Westinghouse
Electric Corporation

NS-TMA-2312

Subject: Review of WCAP-9292

Enclosed are fifty (50) copies of responses to NRC questions on WCAP-9292 entitled "Dynamic Fracture Toughness of ASME SA 508 Class 2a and ASME SA 533 Grade A Class 2 Base and Heat Affected Zone Material and Applicable Weld Metals." The enclosed (non-proprietary) information is being provided in response to the Materials Engineering Branch request for additional information received via the July 25, 1979, letter from J. F. Stolz (NRC) to T. M. Anderson (Westinghouse).

FIGURE 120.6-1 — Temperature dependence of yield strength and fracture toughness for an ASTM A471 NiCrMoV rotor steel

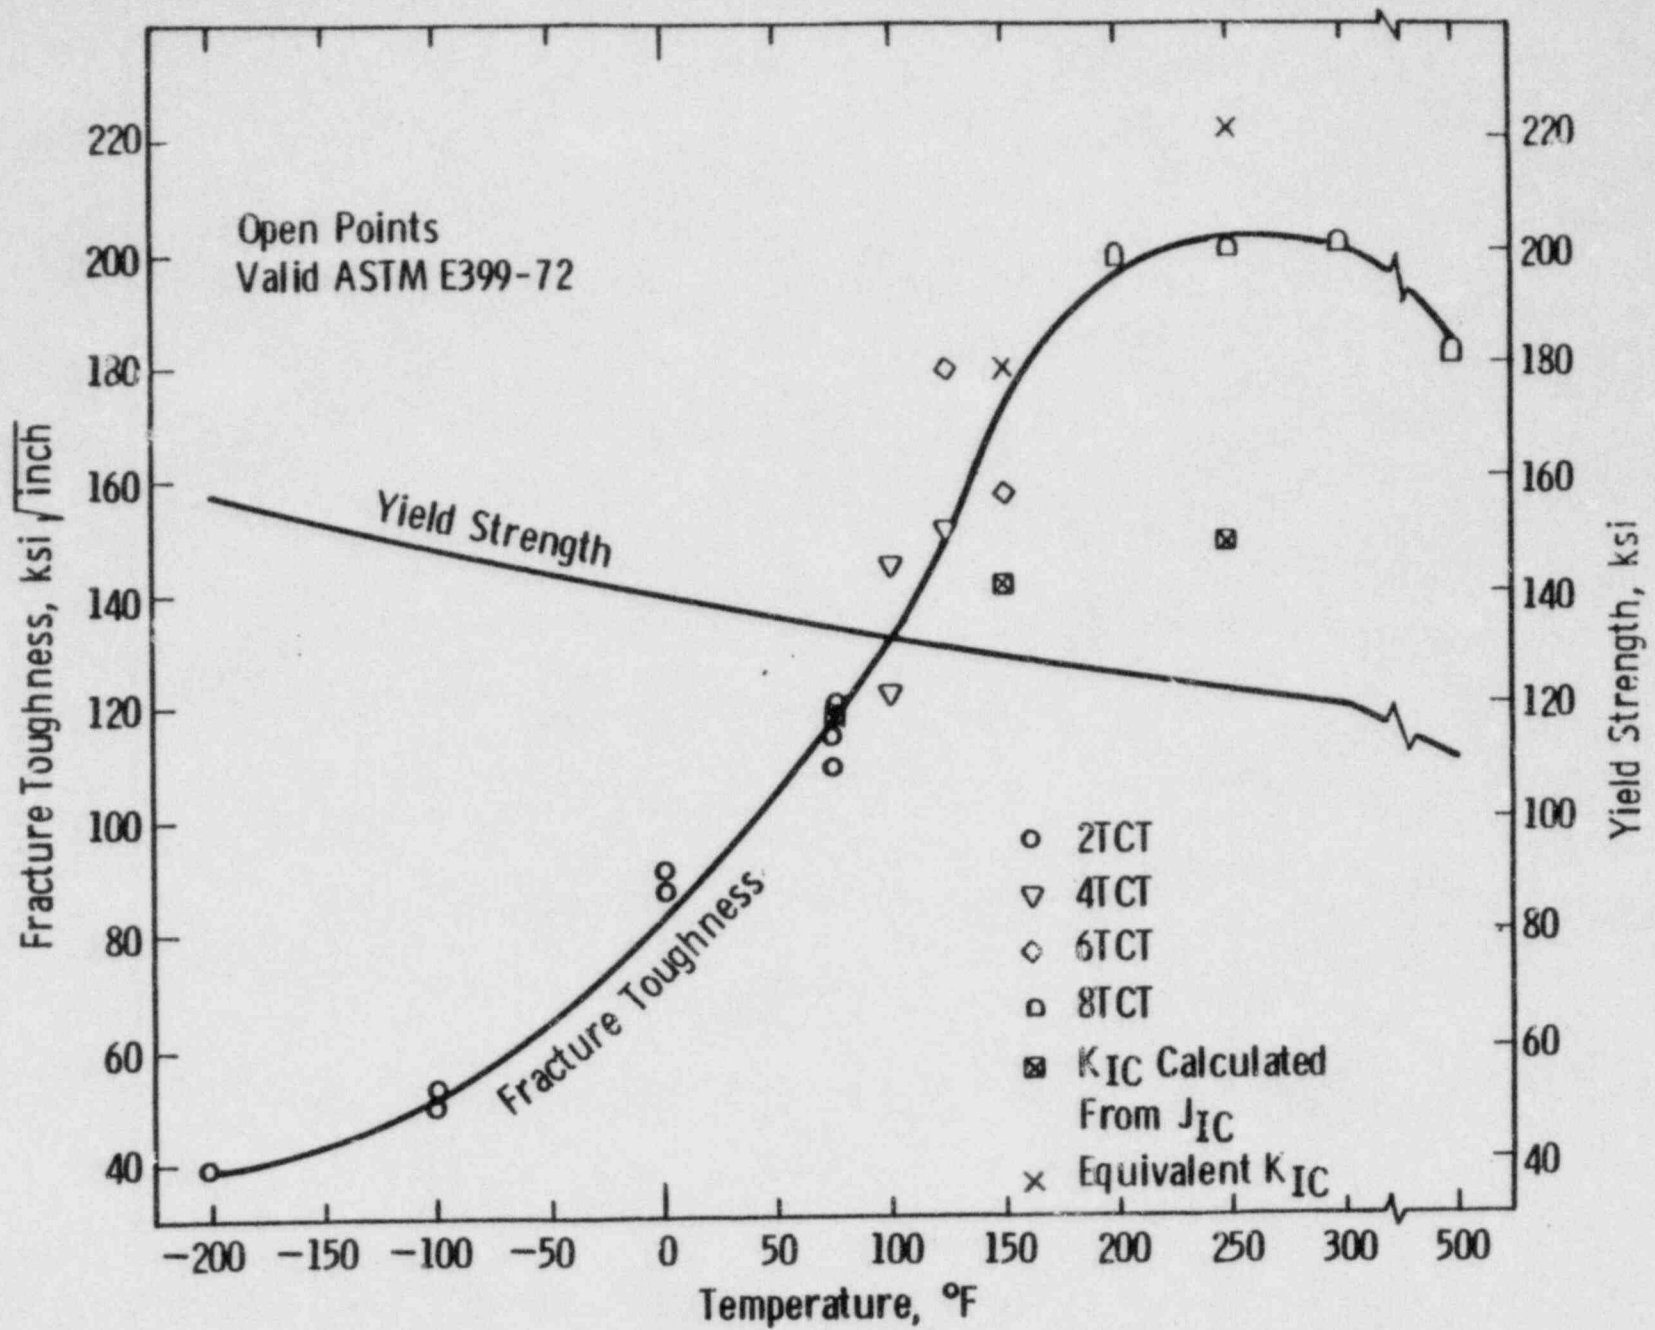
Paragraph G-2110(b), Appendix G, Section III of the ASME Code states that the K_{IR} curve may be used for steels having a minimum specified yield strength greater than 50 ksi, but less than or equal to 90 ksi, if fracture mechanics data similar to the K_{ID} data of WRCE-175 are obtained for this material and if all of the data fall above the K_{IR} curve. This topical report utilized linear elastic K_{ID} tests at low temperatures and J-integral R-curve tests at the upper transition region and upper shelf region temperatures to evaluate the dynamic fracture toughness of SA 533 Grade A Class 2 and SA 508 Class 2a steels and demonstrate compliance with the code requirement.

To demonstrate the adequacy of SA 508 Class 2a steel in the upper transition region and upper shelf region, the topical report should be modified to include either

- (1) one or two additional J_{ID} test results (from actual testing or from the literature) at a test temperature of at least $T-RT_{NDT} = 150^{\circ}F$; or
- (2) an Appendix G type analysis that demonstrates the adequacy of the maximum experimental K_{ID} values obtained in this investigation for the material as used in actual components at normal full power operating conditions.

Logsdon has compared the upper shelf fracture toughness values developed via K and J test techniques for several materials.^(1,2) Of particular interest are the results for an ASTM A471 NiCrMoV rotor steel (see Figure 120.6-1), where the upper shelf fracture toughness values were developed utilizing 8TCT specimens. In particular, at 250°F (121°C) fracture toughness based on crack initiation (J) equals approximately 150 ksi $\sqrt{\text{in}}$ (166 MPa $\sqrt{\text{m}}$) while the linear elastic fracture toughness values are slightly in excess of 200 ksi $\sqrt{\text{in}}$ (221 MPa $\sqrt{\text{m}}$). Seven inch thick specimens would be adequate to obtain valid ASTM E-399 fracture toughness values for this material at 250°F (121°C). The 250°F (121°C) resistance curve for this material (see Figure 120.6-2) extrapolated to 0.140 in. (0.36 cm) of crack extension (equivalent to 2 percent effective crack growth in a seven inch thick

compact tension specimen) yields a J value of $1500 \frac{\text{in-lb}}{\text{in}^2}$ ($0.263 \frac{\text{MJ}}{\text{m}^2}$). The corresponding equivalent fracture toughness value equals approximately $220 \text{ ksi } \sqrt{\text{in}}$ ($224 \text{ MPa}\sqrt{\text{m}}$) and is plotted in Figure 120.6-1. This equivalent fracture toughness value exceeds the linear elastic fracture toughness values because a portion of the allowable effective crack growth in the linear elastic K_{IC} test is used up as plasticity (crack blunting), the remainder going into actual crack extension.
